Access Compliance Report

Public Rights-of-Way

Intersection ID: 19216	Main Street: RAMA_RD	Cross Street: SARDIS_RD	Location: SW
ADA ID: 4641B06ED1BD	Ramp Type: IslandPerp	Initial Pass/Fail: Fail	Overall Compliance: No
Severity Score: 8.75			
Codes/Mitigation Info/Possible Solution		Field Measurements/Component Compliance

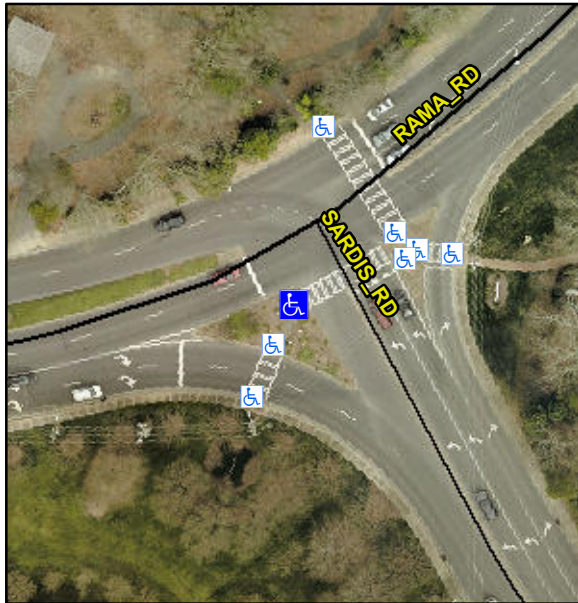
Not Found, R304.5.1

Remove & Replace Entire Ramp.
